PLAN COMMISSION/HISTORIC PRESERVATION COMMISSION WEDNESDAY, JANUARY 22, 2020

PRELIMINARY PLAT OF FINAL ADDITION TO KARA VIEW HEIGHTS

Re Final Addition to Kara View Preliminary Plat - Review Comments

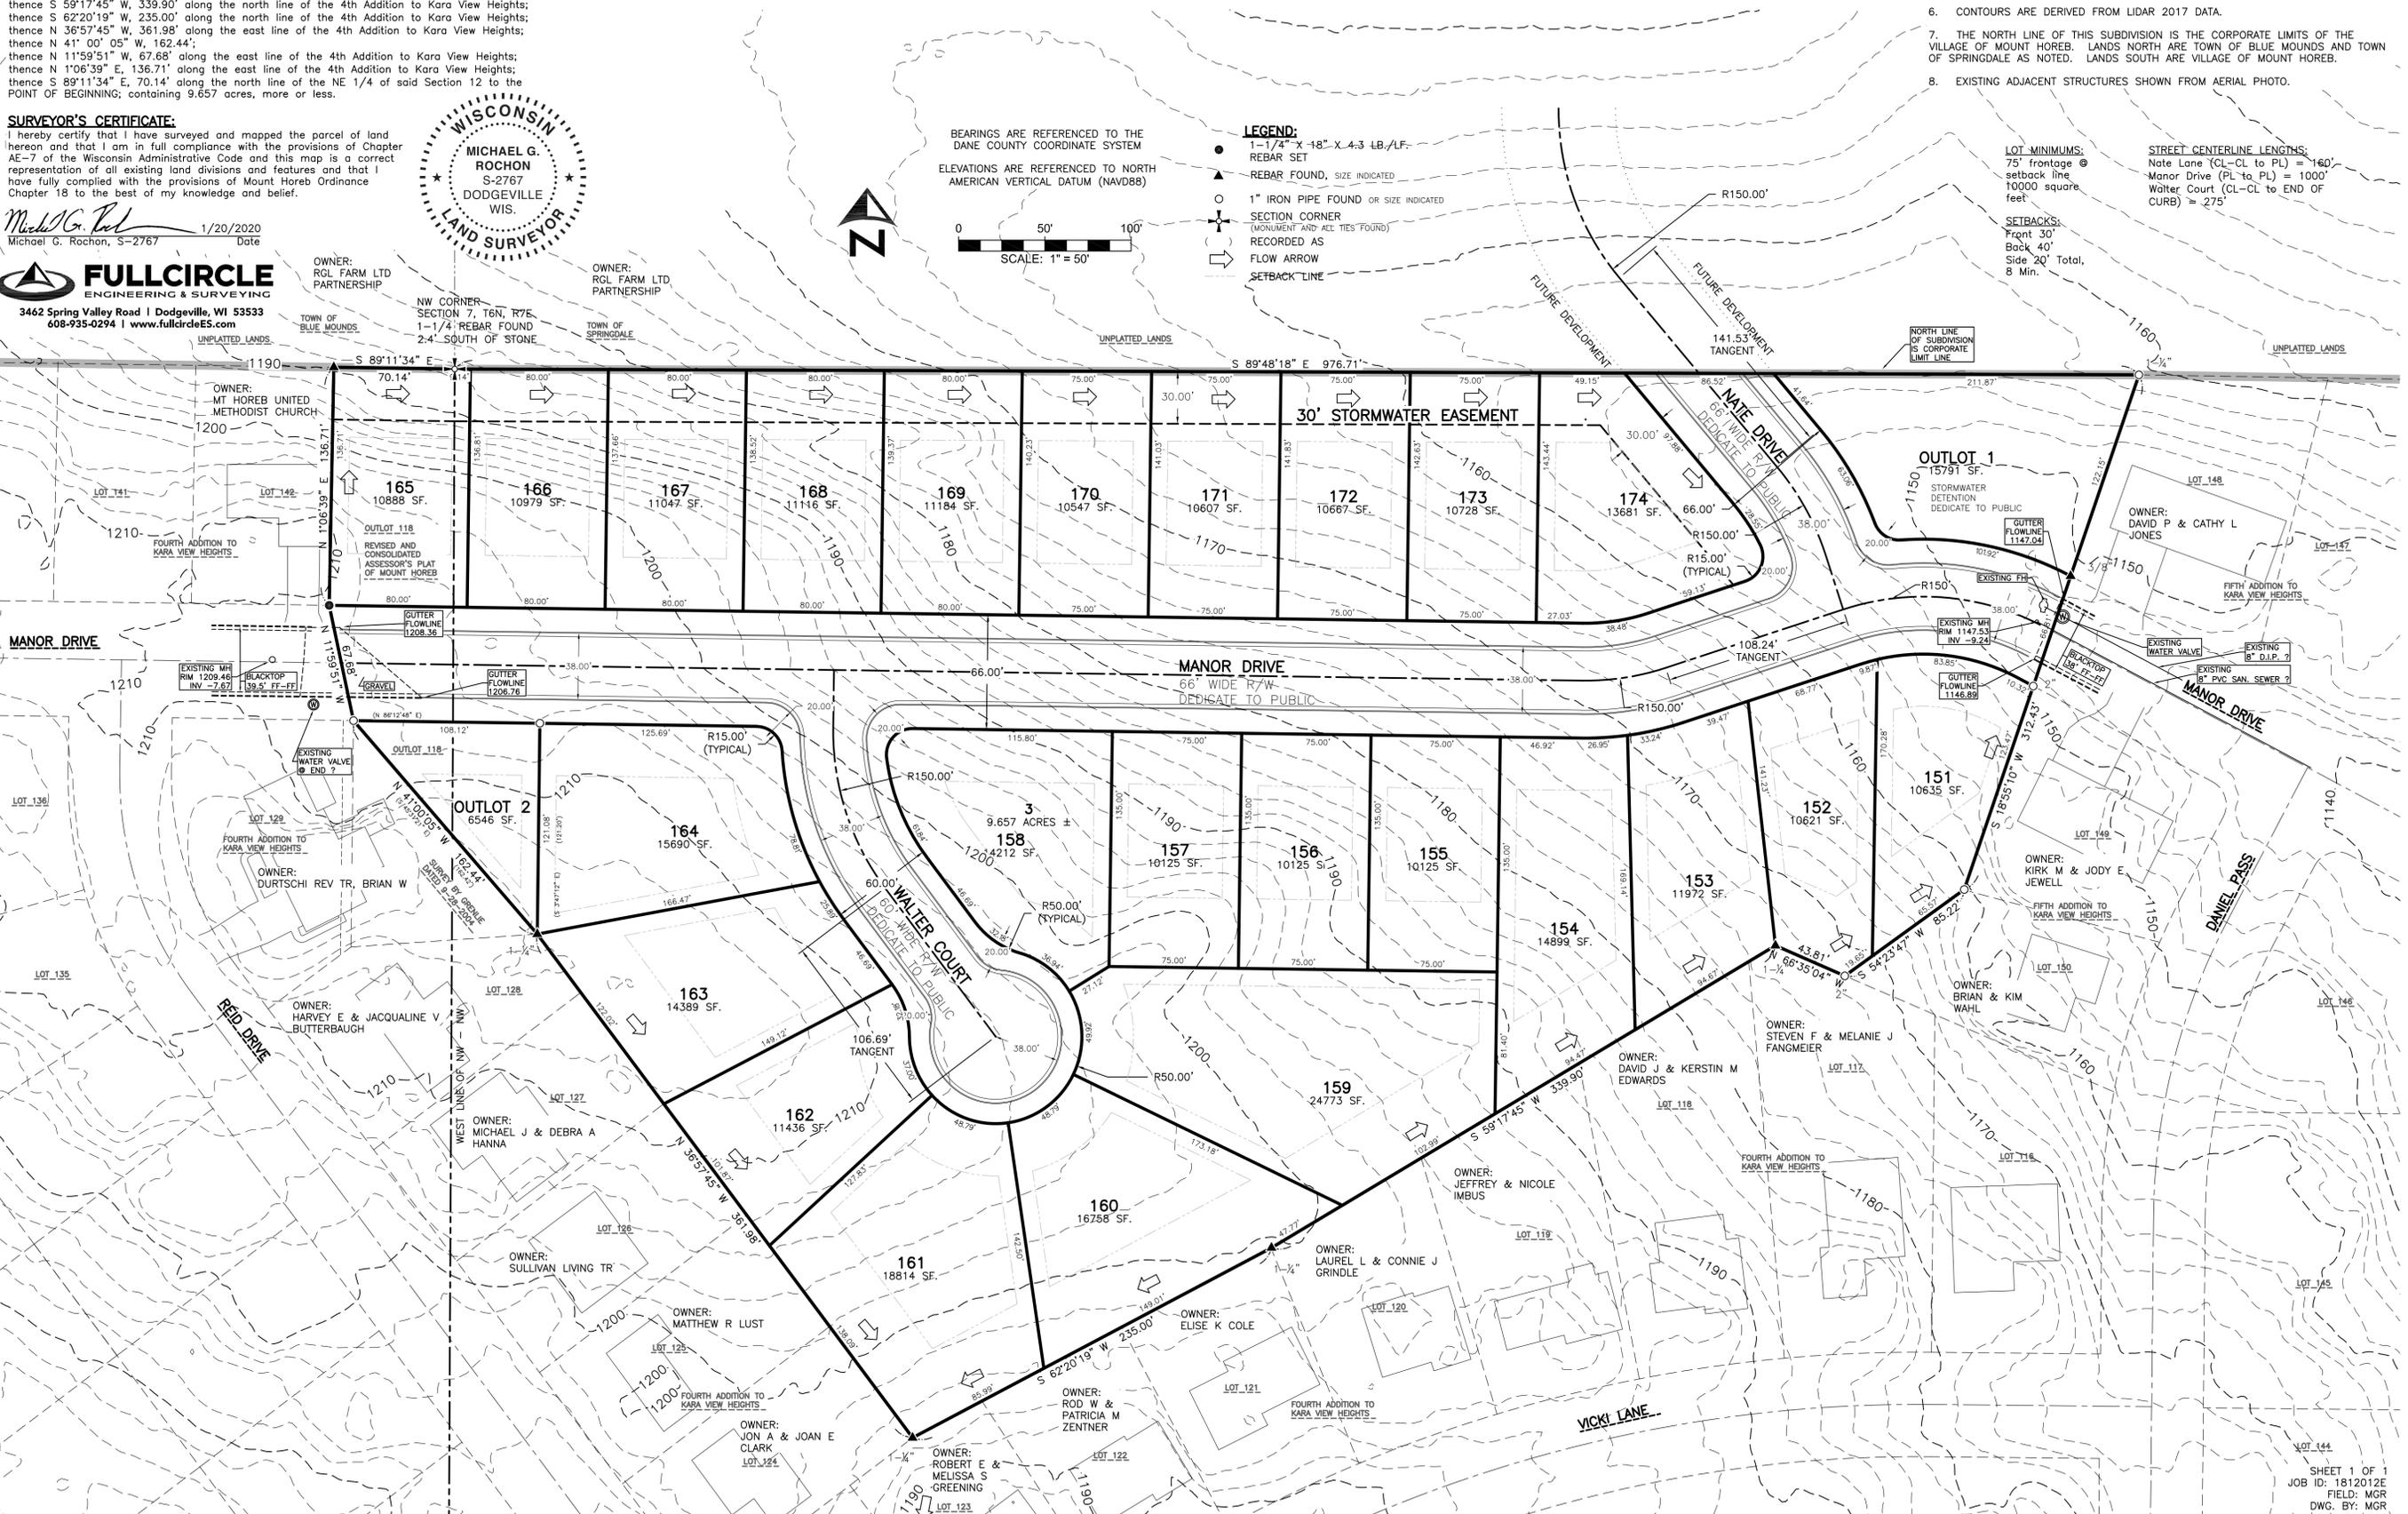
1. VILLAGE LIMITS
 - a. The existing Village Limits are not shown on the Plat.
2. URBAN SERVICE AREA
 - a. This Plat is included within the adopted urban service area boundary per CARPC.

- d. Outlots:
 - i. Outlots are currently shown to remain as A-1 and is inconsistent with standard zoning of these type of parcels. Normally, Conservancy zoning classification would be used.

7. SANITARY SEWER AND PUMPING STATIONS
- a. The following are items to be addressed on the Preliminary Plat - Plans for Kara View Heights:
 - i. Add existing sanitary sewer invert and rim elevations

- ii. Add proposed sanitary sewer invert and rim elevations
 - iii. Verify depths of sanitary sewers will be able to serve all lots via gravity service from the basement.

- iv. Depict laterals on drawings.
8. WATER MAIN SIZING AND LOOPING
- a. The following are items to be addressed on the Preliminary Plat Plans for Kara View Heights:

- i. Review Village of Mt Horeb Standards for installation of water mains (i.e. spacing of valves to fittings)
 - ii. It appears that the horizontal separation between the sanitary sewer and water main may not meet the minimum required (10 feet) by §18.50(3)(d)(4), as dimensions were not provided.

- iii. Dimension and label minimum depth of cover on water main in profile and offset to sanitary sewers.
 - iv. Dimension water and sewer main crossings in profile to determine adequate separation.

- v. Show and label water service length, size, and curb stop to all lots.
 - vi. Dead end/blowoff hydrants shall be provided on Nate Drive at the plat line.

- vii. Valves at all intersections to be added.
 - viii. Watermain layout between Lots 156 and 152 on Manor Drive to be reviewed further due to crossing of sewer mains @Sta 7+00

- i. Narrative
 - ii. Responsible Party
 - iii. Maps showing drainage areas, Tc flow routes and calculations, and flow directions for each watershed.
 - b. As currently submitted, the road grades, plat grading, and storm sewer layout does not support the collection and treatment of all events up to and including the 100-year event as has been depicted on the model.

- c. Storm water management facility outfall appears to daylight to the Manor Drive curb line at the southeast corner of Outlot 1. This will create a hazard to the existing Manor Drive roadway and existing residents regarding discharges during cold weather events. Delayed, extended and constant discharge during warm weather months will be detrimental to the roadway longevity. We strongly recommend requiring the Developer to install an extension of storm sewer capable of discharging the 10-year event in the

- d. An open channel of size and grade to accommodate the 100-year storm event is required per §18.46(6) and the storm sewer shall be sized to accommodate the collection and treatment of all these storm events.

- g. Per §18.50(3)(c)(11), all storm sewers shall be laid with a minimum 15 inches of cover from the subgrade. Profiles or added information on the storm sewer system has not been provided. It appears that revisions are needed.

- h. Per §18.50(3)(c)(5), storm sewers and inlets shall be provided as necessary to limit the encroachment of stormwater towards the street centerline for the 10-year storm. Current inlets depicted on the plans will be inadequate to prevent the spread as well as inadequate to convey the 10-year event (or greater) to the detention pond.
- i. Lots 160-163 are shown to drain undetained to the south corner of Lot 161 and off the proposed plat thru Lot 123 of the 4th View of Kara View Heights.
- j. It is our recommendation that the Stormwater Management Facility located on Outlot 1 will be required to be maintained by Developer's HOA and will not be a public facility.

- a. Sidewalks are not currently shown on Manor Drive or Nate Drive. It is our understanding that the Village Board and/or Plan Commission have allowed this deviation from Village Standard.

- b. A typical roadway section was not provided that details roadway widths and construction of pavements and curbs.
- c. Roadway widths are not dimensioned on the drawings.

- d. Tangents on the centerline on Manor Drive between the reverse curves near Nate Drive shall be labeled and shall be a minimum of 150-ft (§18.41(4)(b)).

- e. Temporary turn around or other improvements to be included on Nate Drive at the connection to the un-platted lands outside of the Village to the north. Fees payable to the Village Road Improvement fund may be required in order to remove and complete further phases of Nate Drive that are outside of the Village Limits.

- f. Roadway Vertical Curves on Walter Court do not meet minimum value of 20 (§18.50(3)(e)).
- g. At intersections, vertical curves shall be provided on the side streets when the absolute value of the intersecting grade of the side street is greater than 3 percent. The minimum length of the vertical curve in feet shall be 10 times the intersecting grade of the side street or 50 feet, whichever is greater. (see attached sketch)

- a. Walter Court appears to exceed maximum allowable street grade (6%) for last 50 feet of pavement per §18.50(3)(e)(6).
- b. Vertical curves to be provided on side streets at intersections where the absolute value of the intersecting grades is greater than 3 percent per §18.50(3)(e)(3). To be further refined during final plan review (attached sketch).
- c. For typical street sections, the centerline elevation shall match the top of curb elevation; pavement slope to be adjusted.

- a. Lots in the R-1 district must have a minimum area of 10,000 square feet. All lots must have a minimum width of 75 feet at the building setback line. This plat appears to conform to these requirements. It is noted that the minimum lot width has been used by the Developer on this Plat.
- b. Building setback lines are not shown and should be added.

- b. Existing water, sewer, and gas main sizes need to be shown on the Plat.
 - c. Existing water and sanitary main is depicted on the Preliminary Plat but are not labeled or shown on the profiles.

- d. Existing hydrants are shown on the existing portion of Manor Drive, but water main is not shown.
14. RECAPTURE COSTS, AREA FEES, AND ASSESSMENTS
- a. RW-5 – West Lukken Collecting Sewer Fee

18. Arrows indicating direction of drainage flows will be required on the Final Plat. Arrows as currently shown on selected proposed Lots on the preliminary plat drain offsite and need to be further discussed on potential impact to adjacent property owners.

- a. Owners of record for adjacent “Lands” are not shown.
 - b. Type and width of existing street pavements are not labeled.
 - c. Not all existing structures and drives on adjacent residential lots are shown:

- d. Corporate limit lines are not shown.

Vertical Curve Transitions Required at Intersections

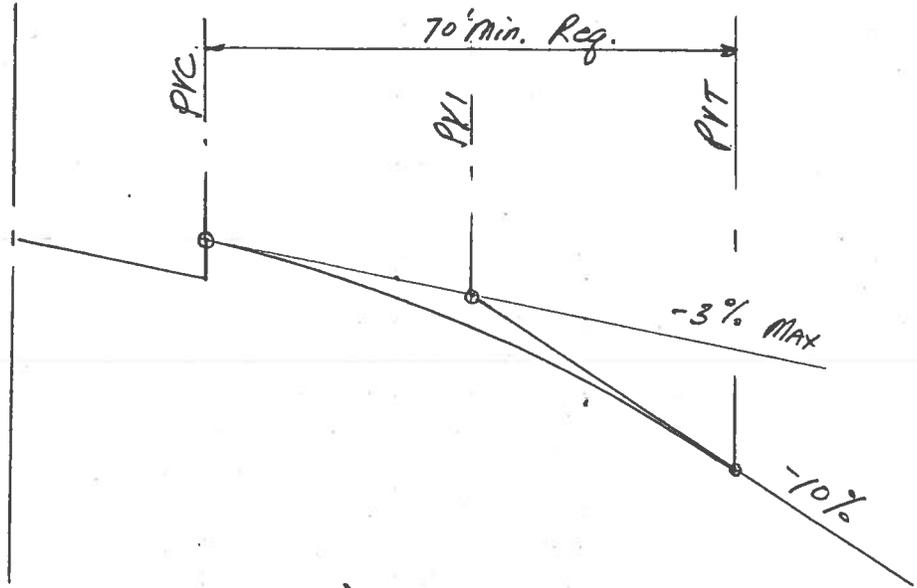
3. At intersections, vertical curves shall be provided on the side streets when the absolute value of the intersecting grade of the side street is greater than 3%. The minimum length of the vertical curve in feet shall be 10 times the intersecting grade of the side street or 50', whichever is greater.

$$10 - 3 = 7(10) = 70' \text{ Req.}$$
